SUBJECT: Response to TAC comments  
Site Plan Application for a Site Redevelopment  
2255 Lafayette Road

# PROPOSED RETAIL MOTOR FUEL OUTLET SITE REDEVELOPMENT PLANS

ASSESSORS MAP 272 LOT 3  
2255 LAFAYETTE ROAD  
PORTSMOUTH, NEW HAMPSHIRE

DETAIL SHEET	
SCALE:	NOT TO SCALE
PROJECT NO.	NEX-2021163
9 OF 14

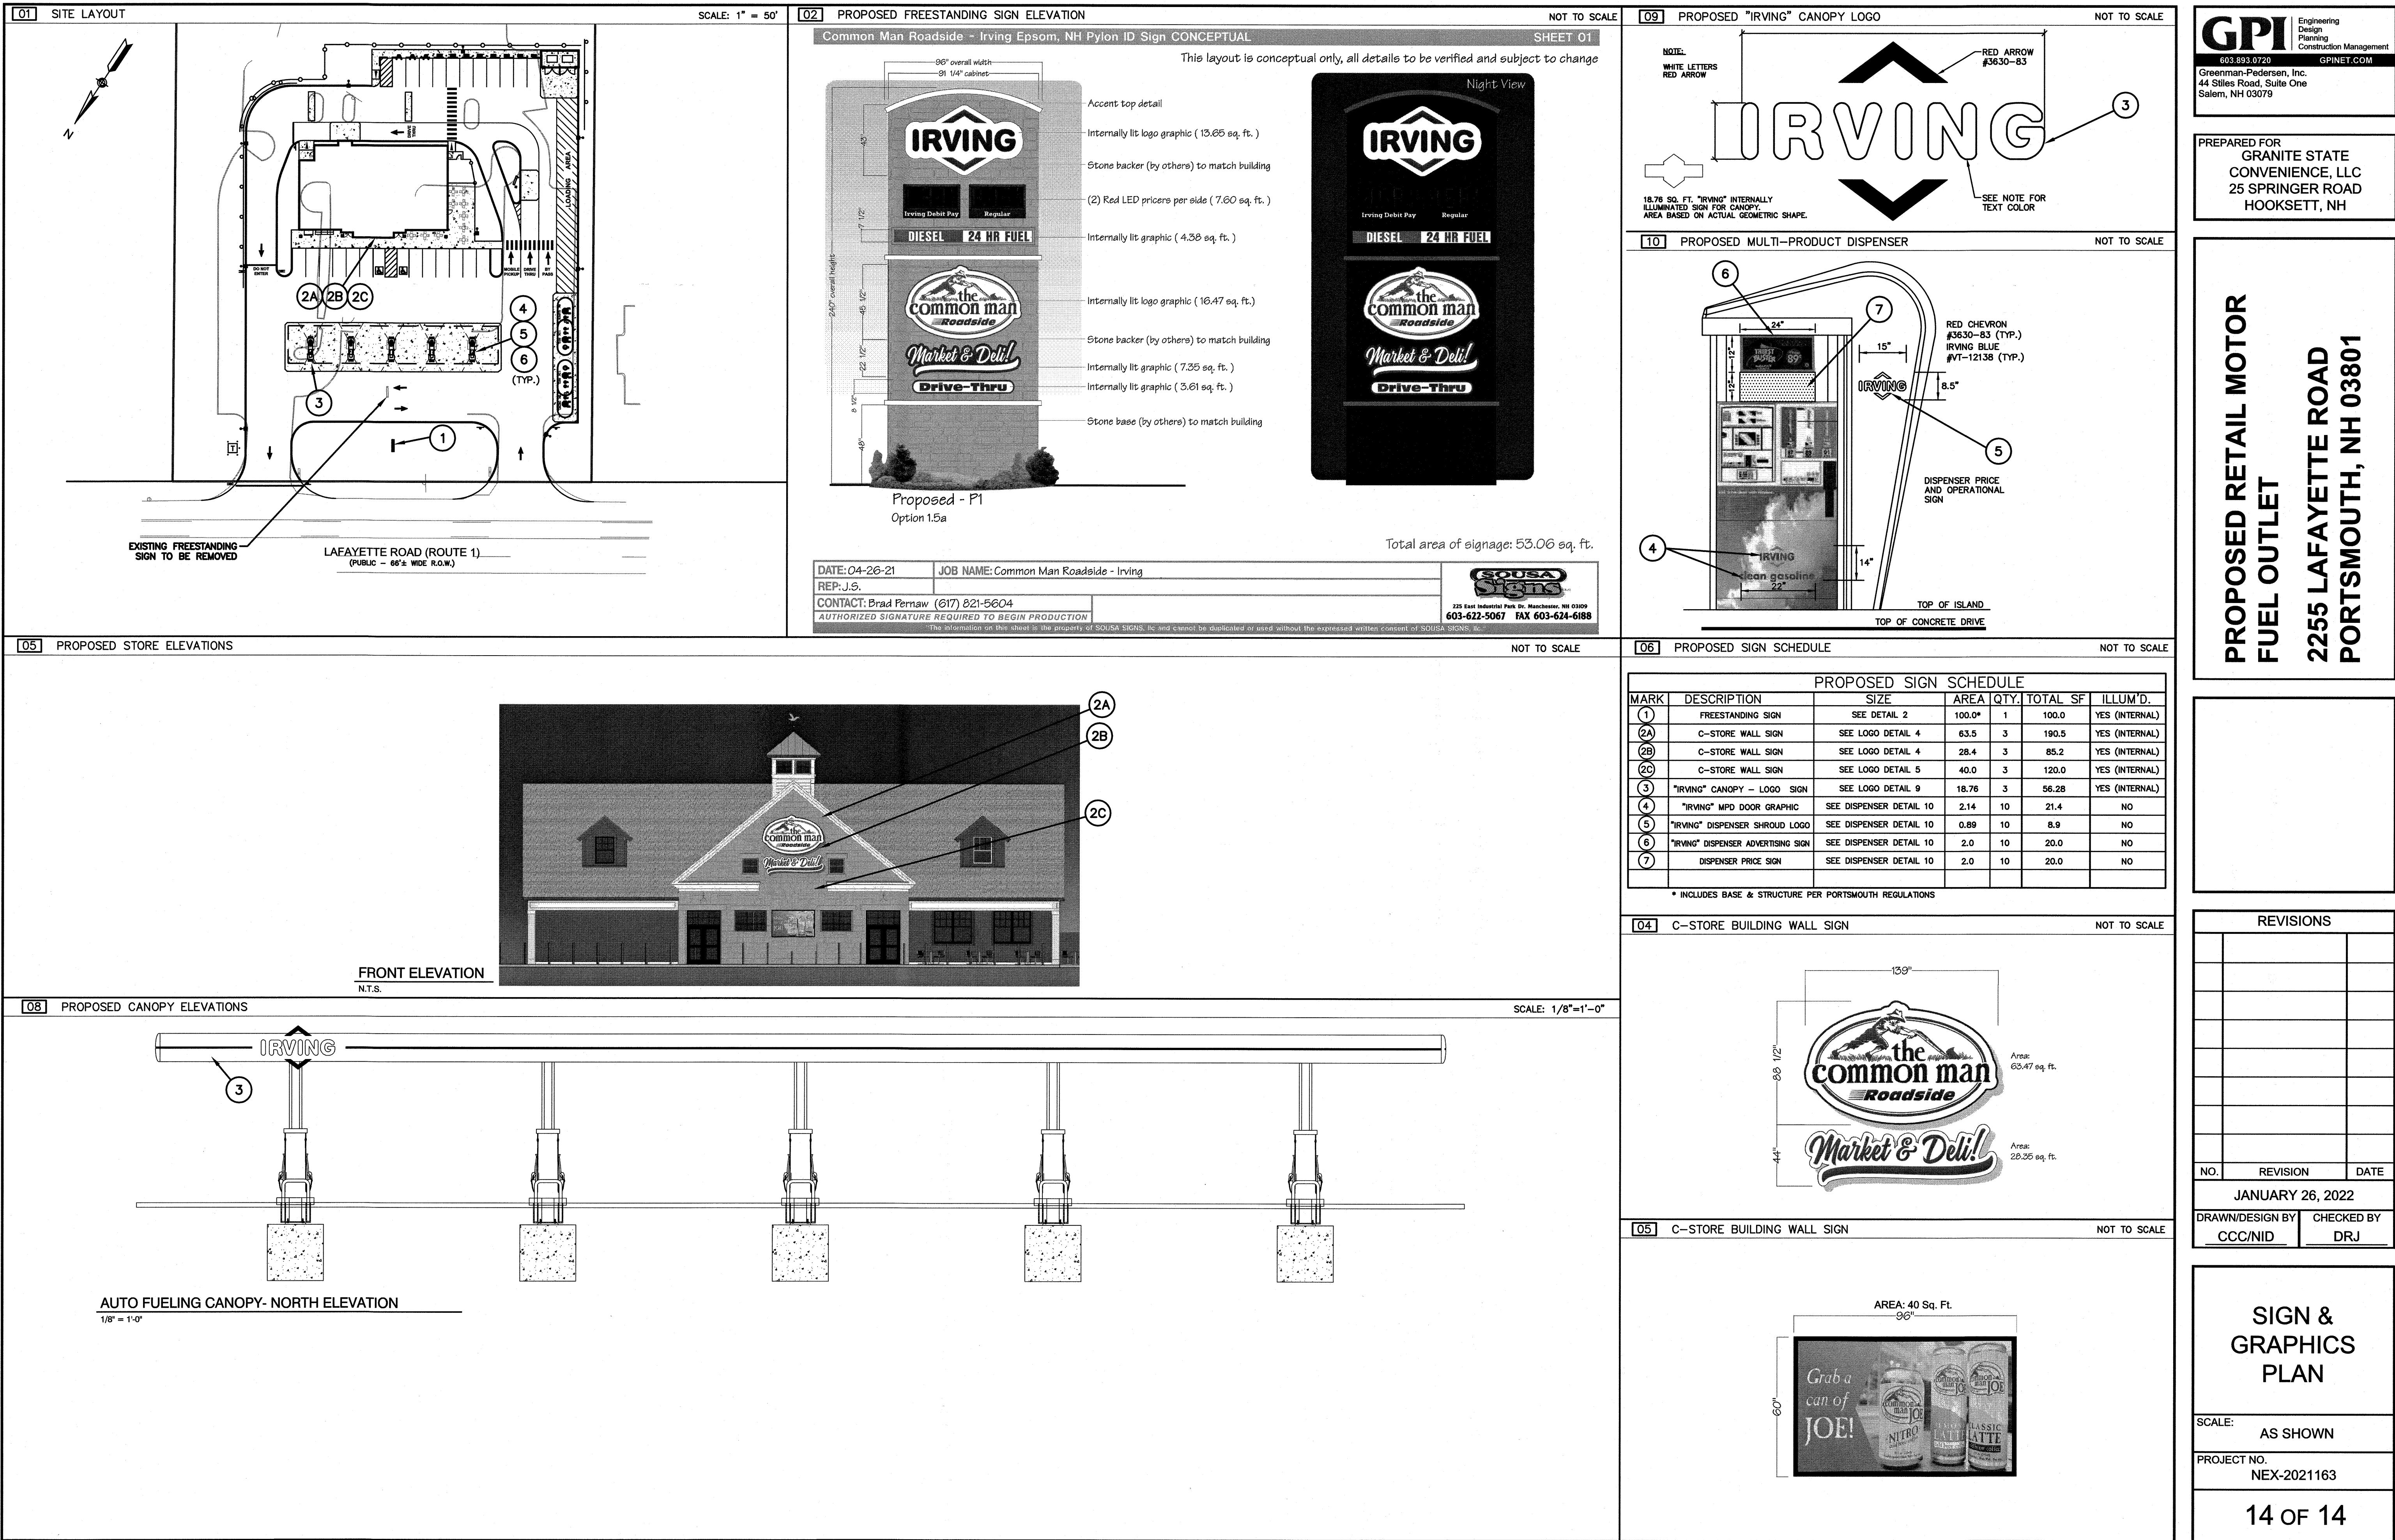
**Response: The Stormwater Inspection & Maintenance Plan was included toward the back of the Stormwater Management Report.**
8. *Multi use path cross section detailing needs to be provided for approval. 2.5" thick asphalt on 8" of crushed gravel base.*

**Response: A new detail has been added to Sheet 9.**
9. *What are the plans for the "future EV charging station"?*  
**Response: The applicant is currently working with Tesla on timing of construction. Most likely conduit will be installed, and area brought to grade for their construction in the future.**

**TRUCK TURN  
PLAN**

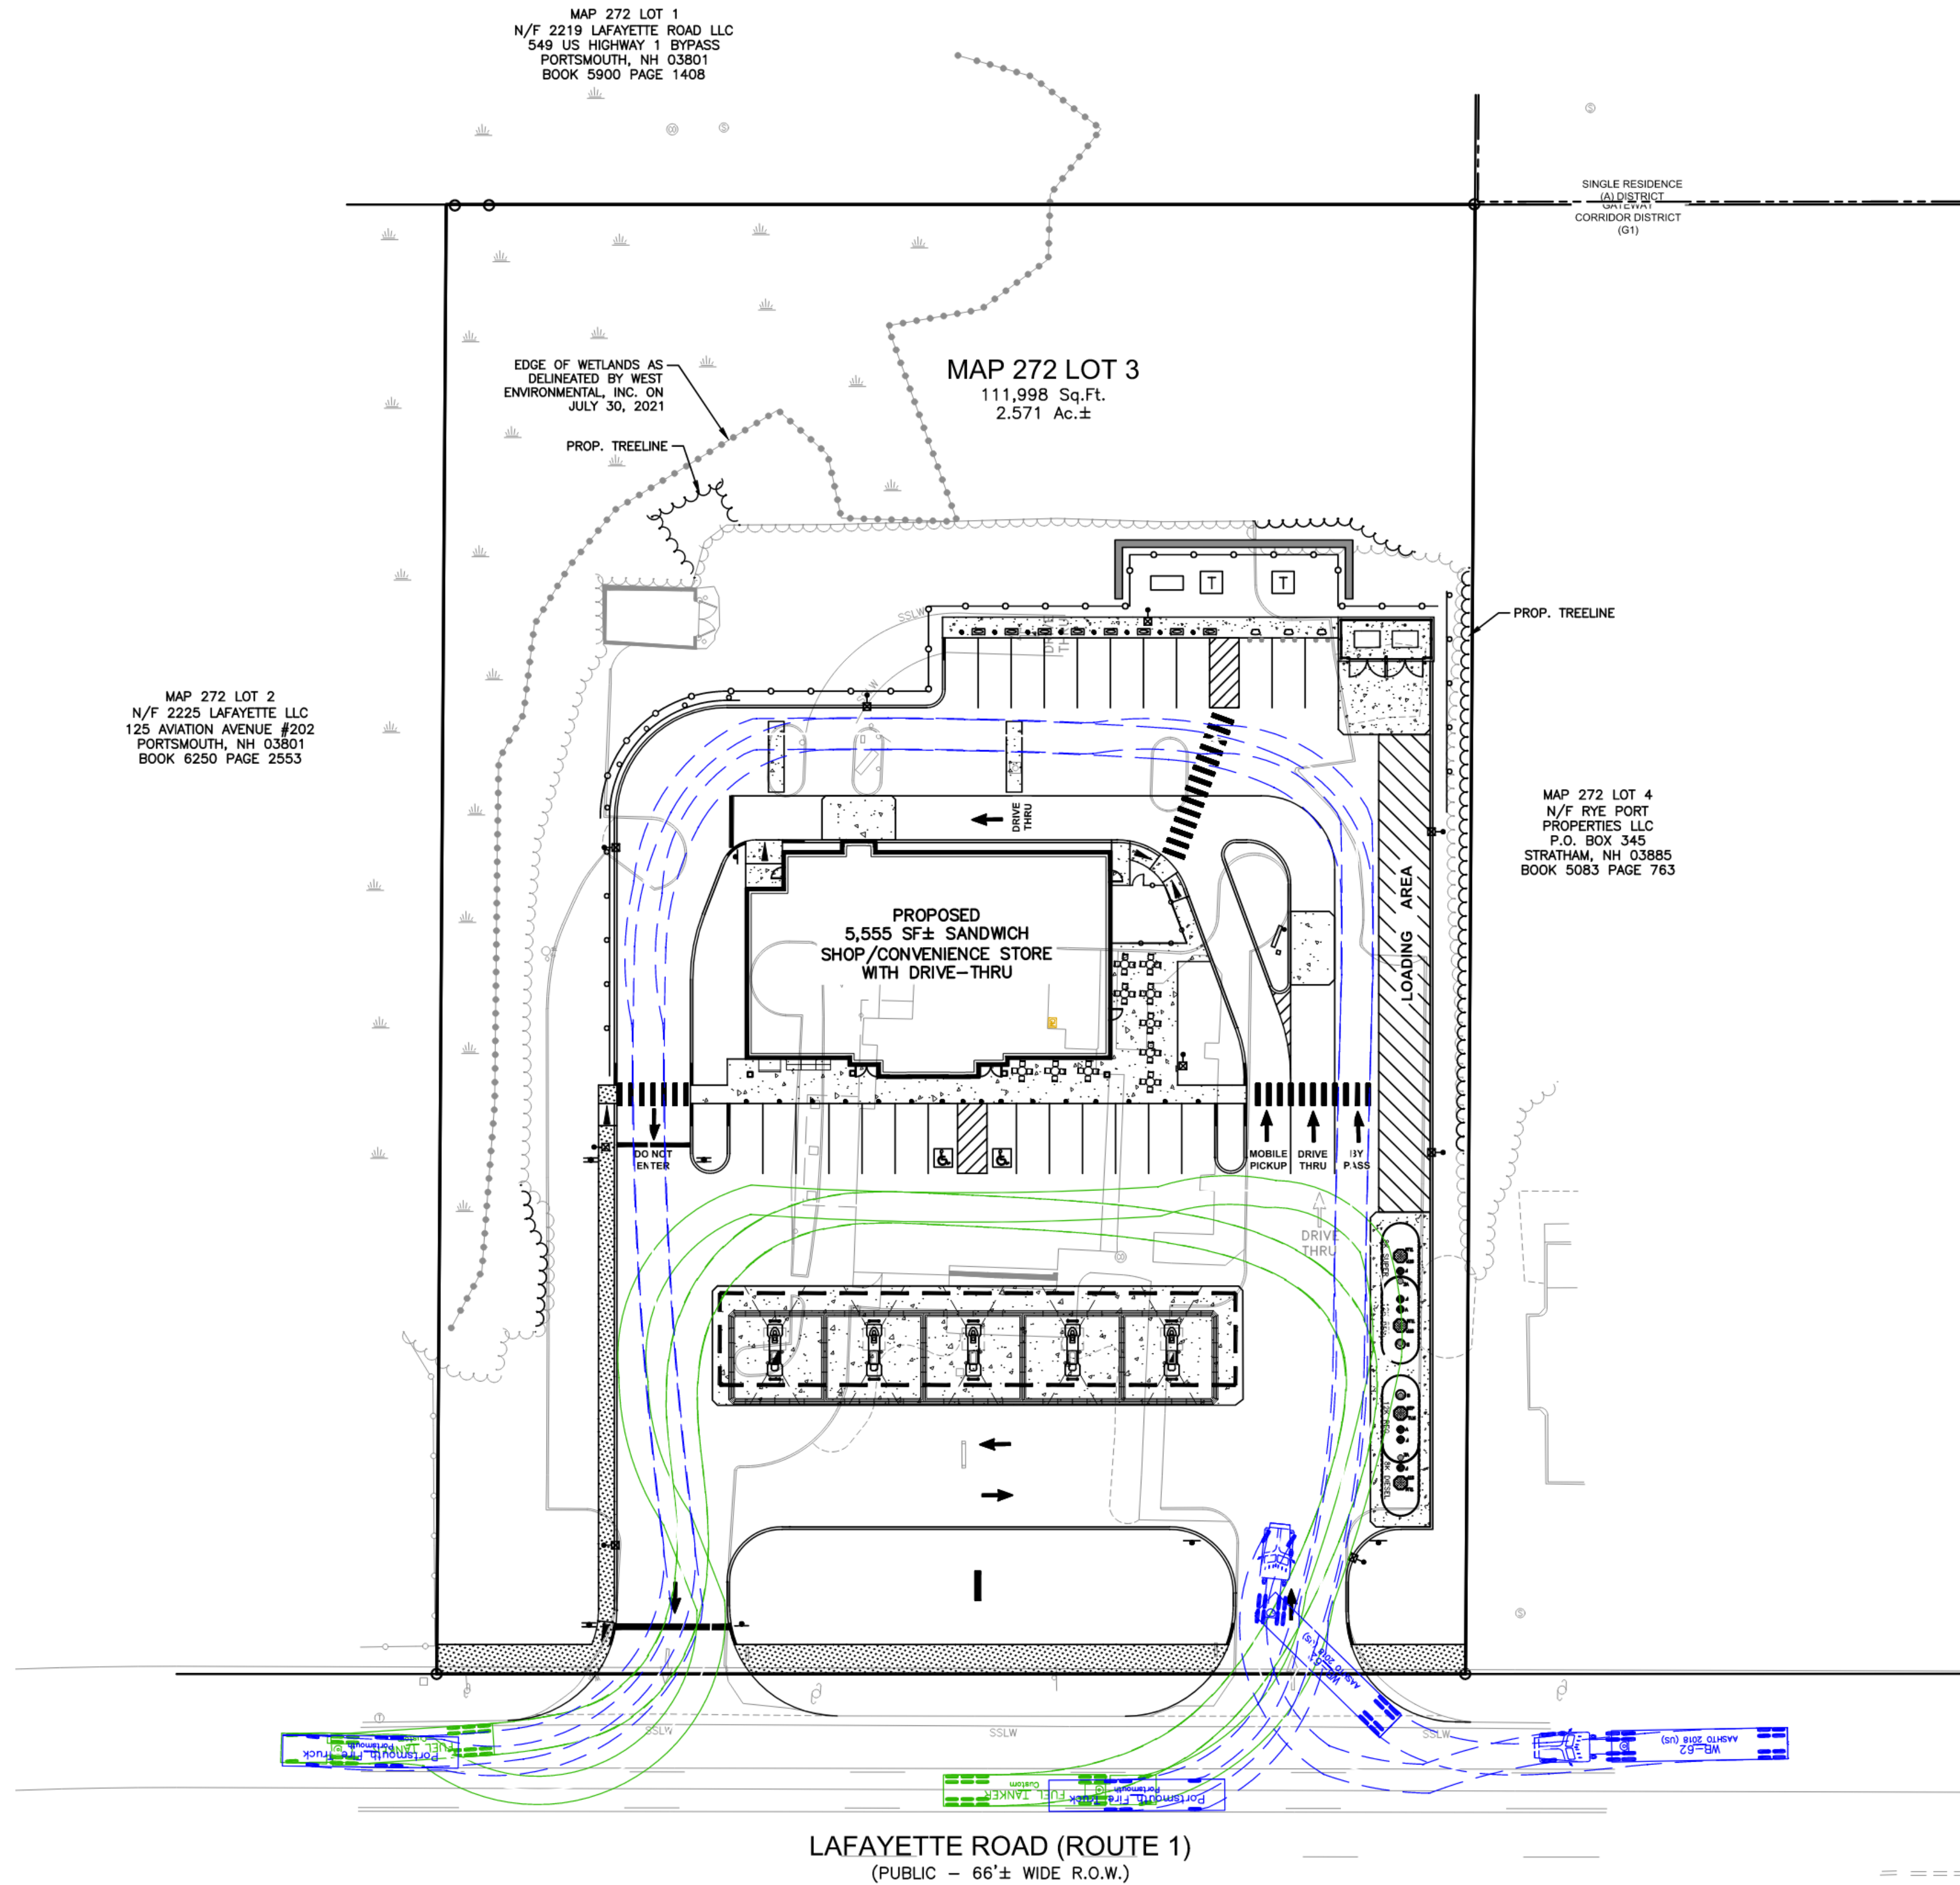
16. *The truck turning plan should show the turning path for a Portsmouth Fire Truck.*  
**Response: The Truck Turn Plan has been revised.**
